Revision Number 1

Date: 07/07/2020
Project: 87799-001
To: Katie Slonski, Chitra Patel, Stephenie Rychlik, Matt Isch, Kristen Sylwestrzak, Edurne Vega, Pierina Benevenuto, Katie Getz, Erika Aultman
From: Alissa Hahn

MO – NW Pryor Rd. & Chipman – REVISION 1

PROJECT NAME:
BILDOUT OF STARBUCKS
COFFEE - NW PRYOR RD &
CHIPMAN - LEE'S SUMMIT
PROJECT ADDRESS:
STREETS OF WEST PRYOR, LOT 3
2050 NW LOWENSTEIN DR.
LEE'S SUMMIT, MO
JACKSON COUNTY

SHEET NUMBER:
G002

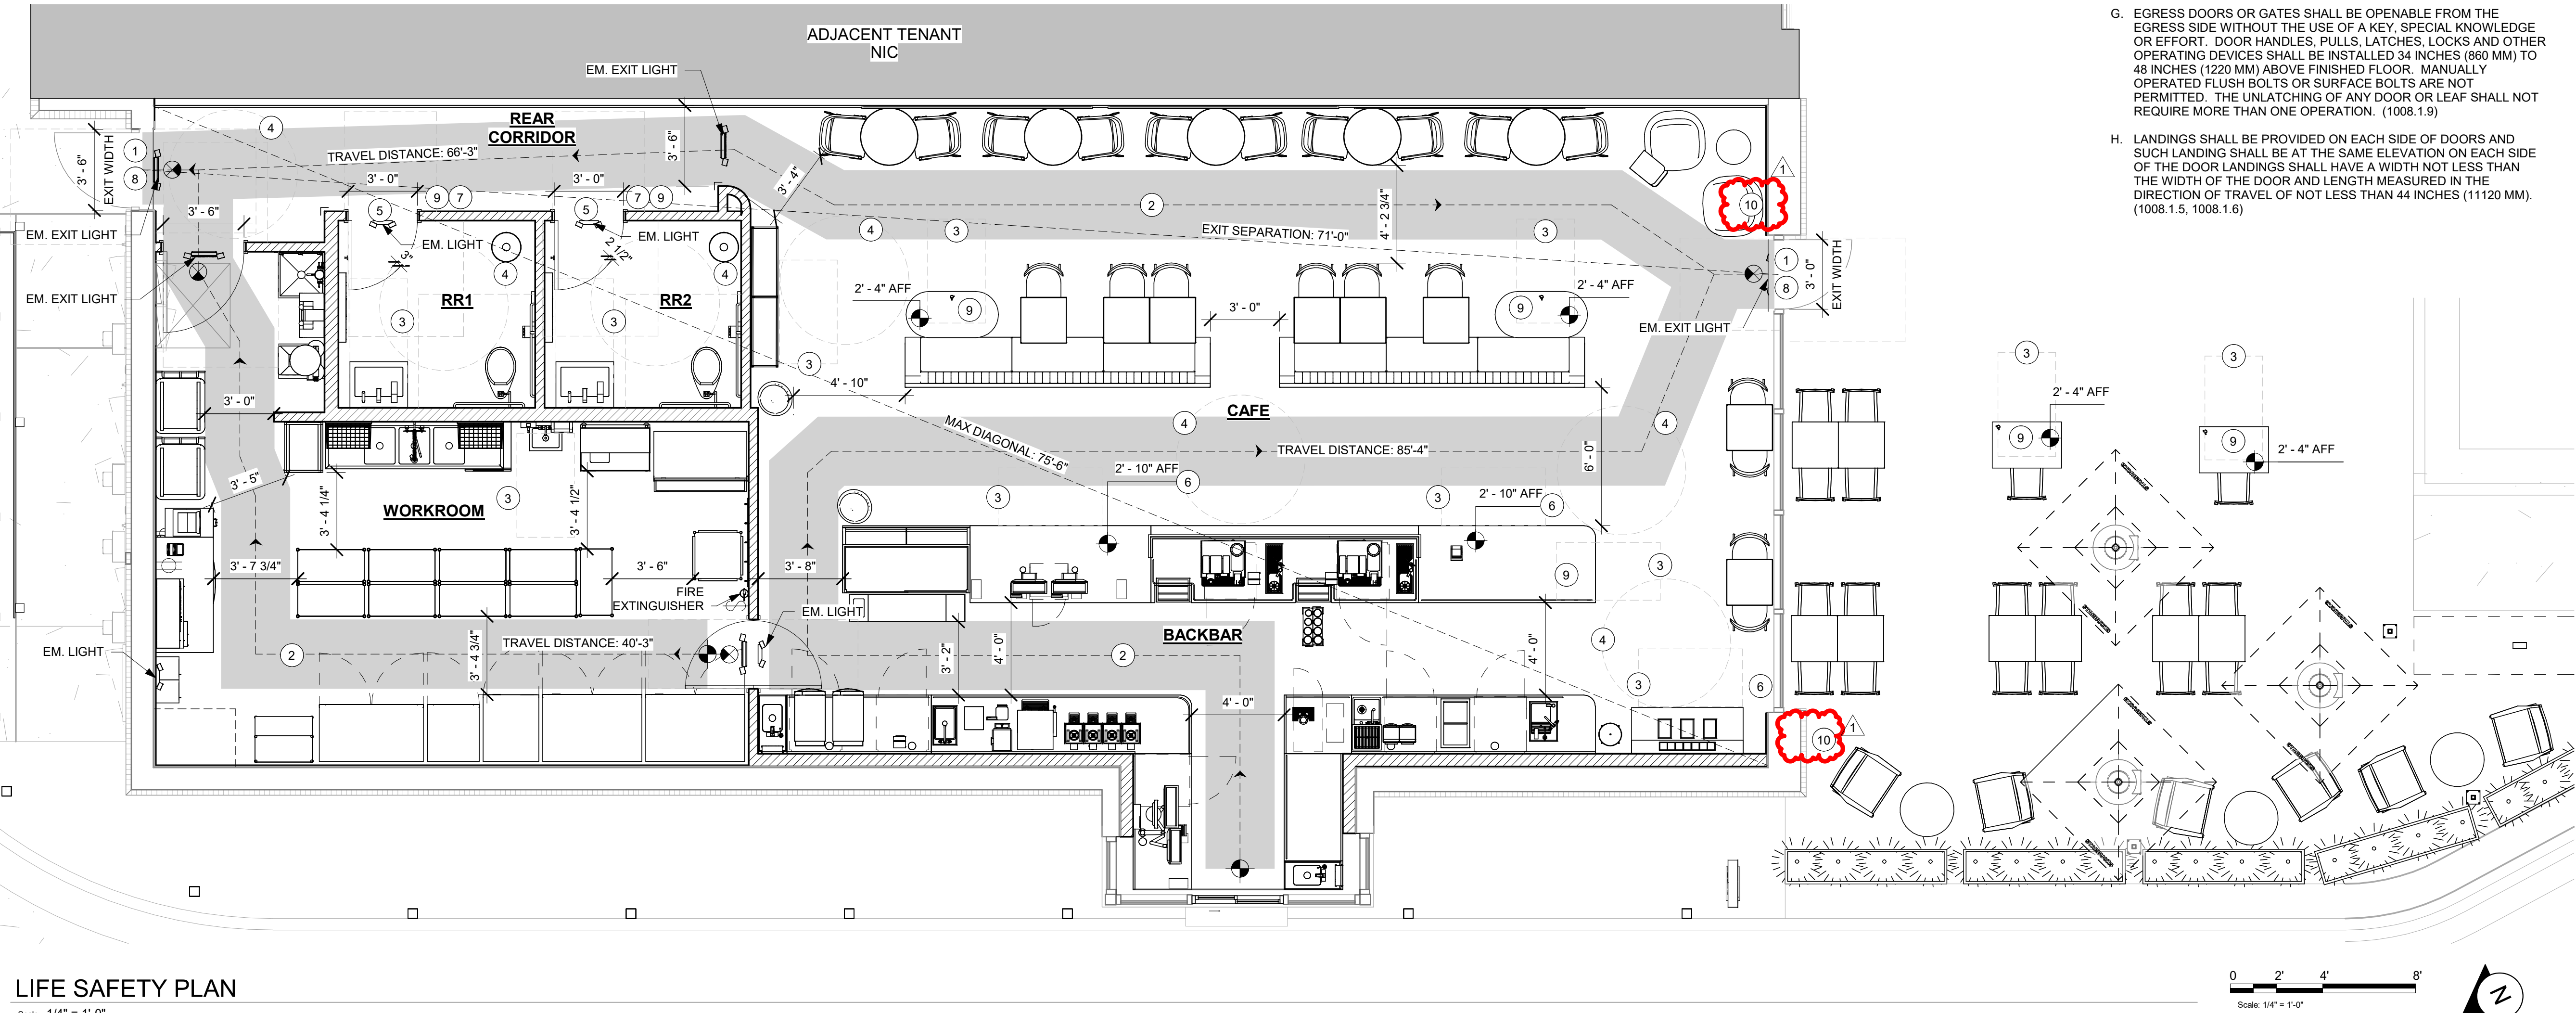
- Sheet G000 Sheet added to display scope of revisions, per Revision 1.
- Sheet G001 Sheet G000 was added to index.
- Sheet G002 Added and tagged key note 10, per Fire Department Comments.
- Sheet A201 Updated key note 1, per Fire Department Comments.
- Added and tagged occupancy sign in elevation #1, per Fire Department Comments.
- Sheet I101 Added and tagged occupancy sign in FF&E Plan, per Fire Department Comments.
- Sheet I202 Added and tagged occupancy sign in elevation #3, per Fire Department Comments.
- Sheet I601 Added occupancy signs to graphics & artwork schedule, per Fire Department Comments.
